AMENDMENTS TO THE DRAWINGS

REMARKS

HIGH VOLTAGE CABLE ASSEMBLY

Fig. 1

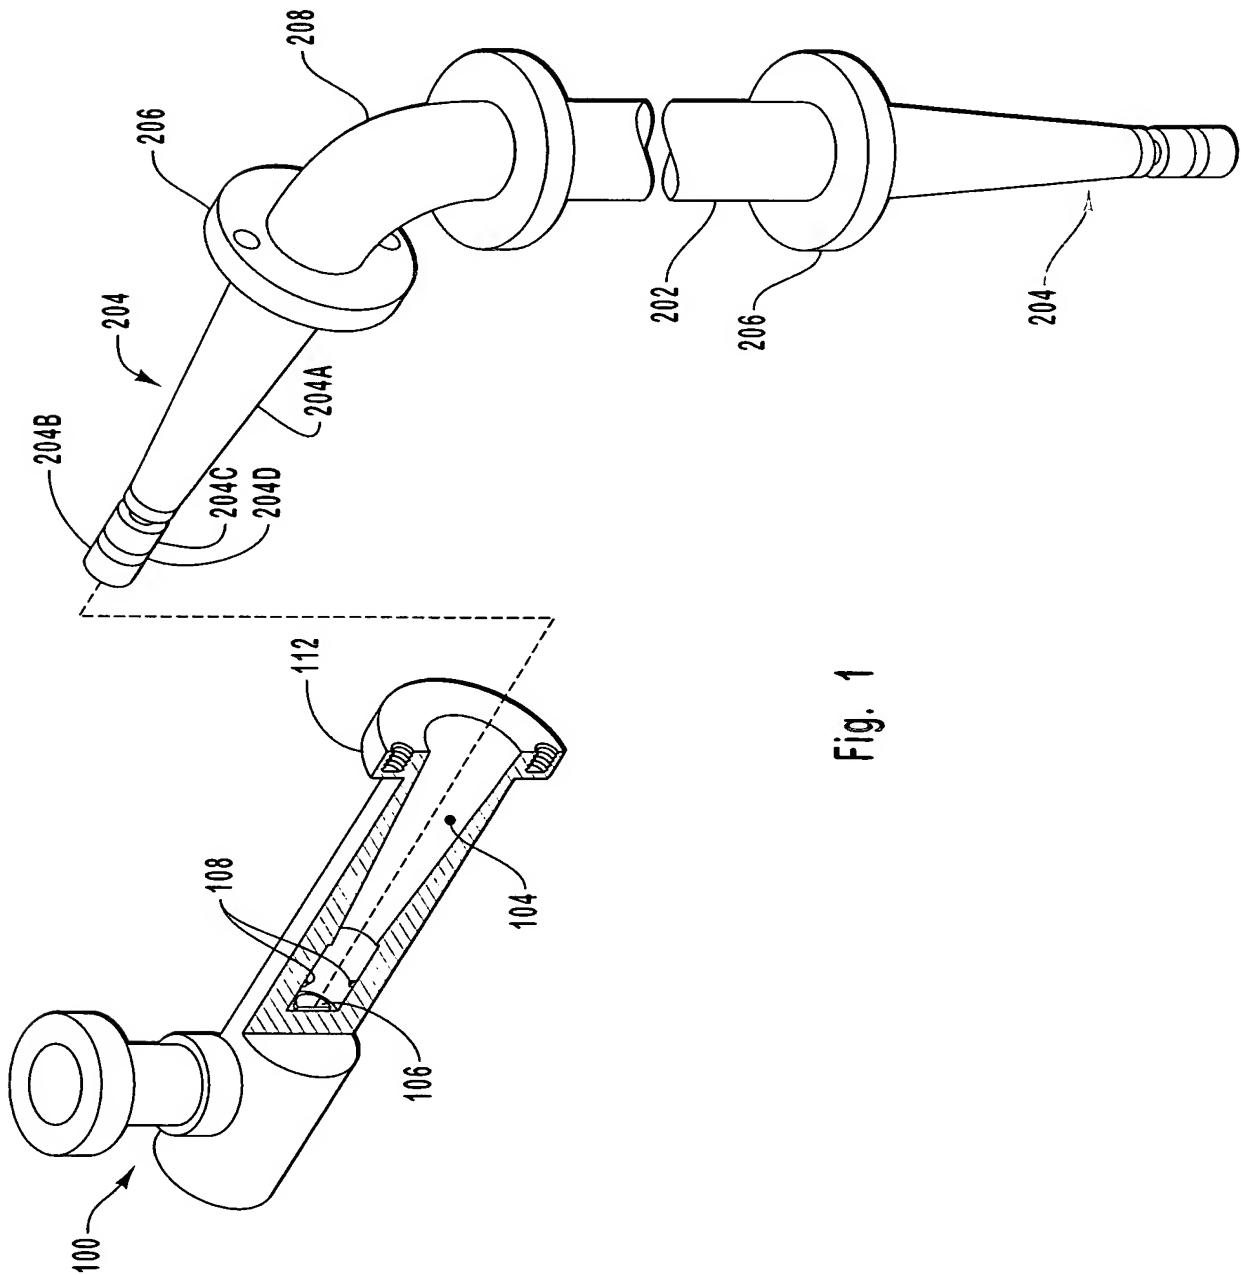
1. The Examiner has objected to Figure 1, apparently on the grounds that the "204" reference sign in the lower portion of the Figure does not include an arrowhead. In light of the Replacement Sheet 1 submitted herewith, Applicant submits that the objection has been overcome and should be withdrawn.

Fig. 2A

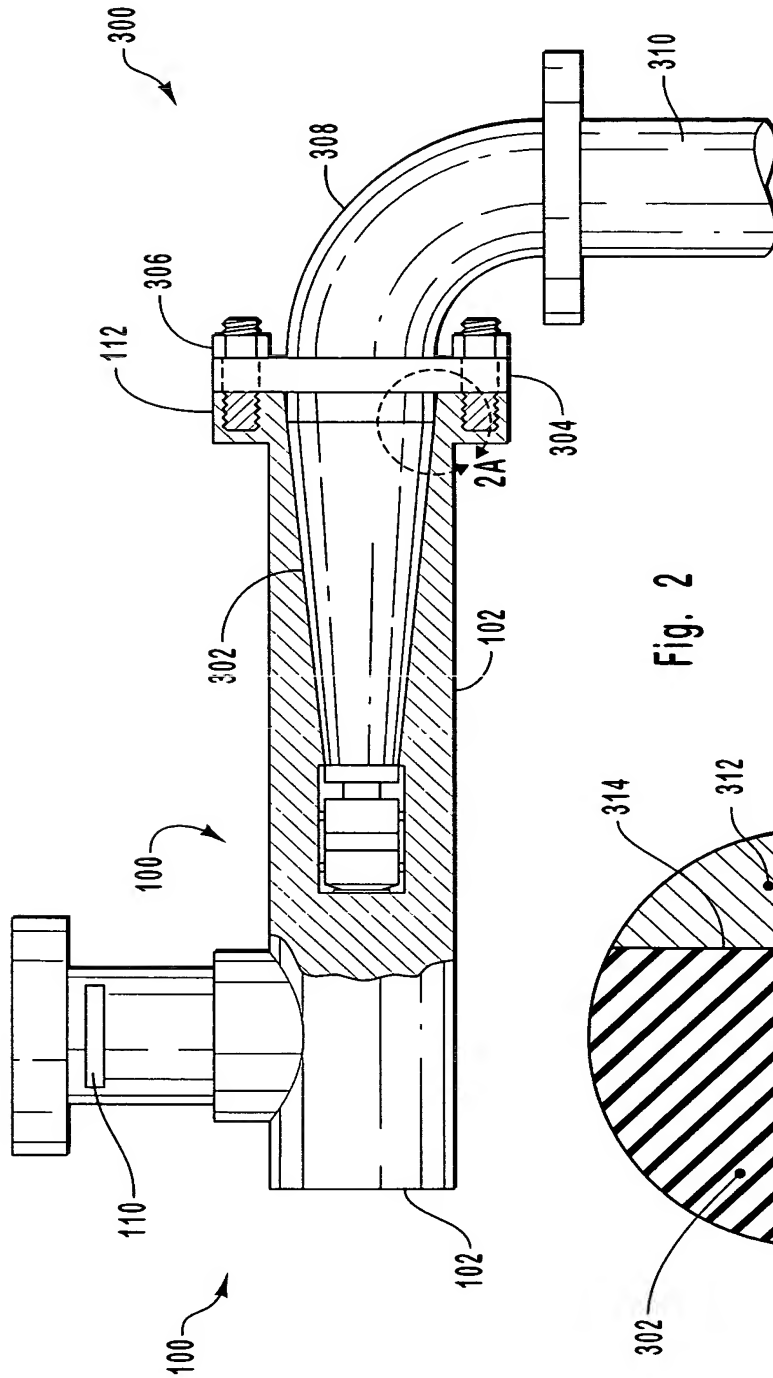
2. The Examiner has objected to Figures 2A and 3A, stating "there are two elements in rightmost portion shown with different hatching, one (numbered 312 in Figure 2A and one numbered 404 in Figure 3A) has hatch line different than those of another just below elements numbered 312 and 404. It is not clear what does the other element belongs to and why there is a gap between these two different elements."

In light of the Replacement Sheets 2 and 4 submitted herewith, Applicant submits that the objection has been overcome and should be withdrawn. With particular reference to Figures 2A and 3A, those figures have been amended to more closely conform with the specification. No new matter is believed to be entered as a result of the modifications to the figures.
